S E R V I C E N O T E

Agilent 4352B VCO/PLL Signal Test Analyzer

Serial Numbers: JP1KE00101 / JP2KE00624

DATE: September 2000

Figure 1 AC Inlet Connector

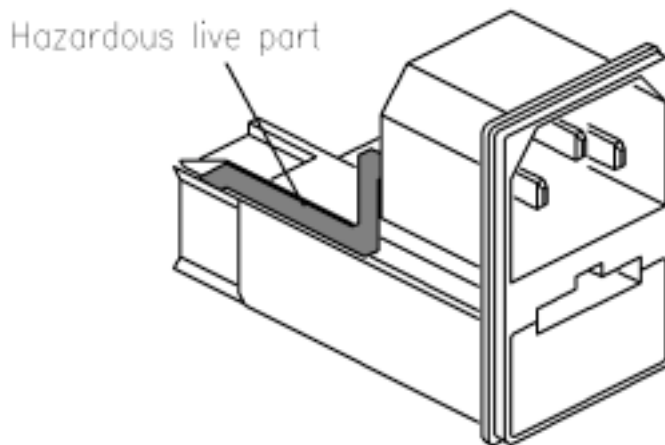
The AC inlet (P/N 1252-6951) has the potential to slip out of the instrument's rear panel slot if the AC power cord is forcefully pulled in a diagonal direction. When this happens, an exposed connection on the AC inlet module may touch the rear panel of the instrument and cause an electrical short if the AC power cord is still connected to the AC power outlet. See Figure 1.

In the worst case, there is also a possibility of an electric shock hazard to the user if the user completes a circuit between the instrument panel and another grounded connection while the AC power cord is still connected to the AC power outlet.

Solution 1. AC Inlet Still Intact.

- Remove the AC power cable from the AC power outlet and the product.
- Remove the top, bottom, and side covers.
- Seal the hot line terminal on the AC inlet with silicon paste (P/N 5183-4112).
- Reinforce the connection between the AC inlet and the rear panel with silicon paste.
- Perform Self Test to verify instrument operation.
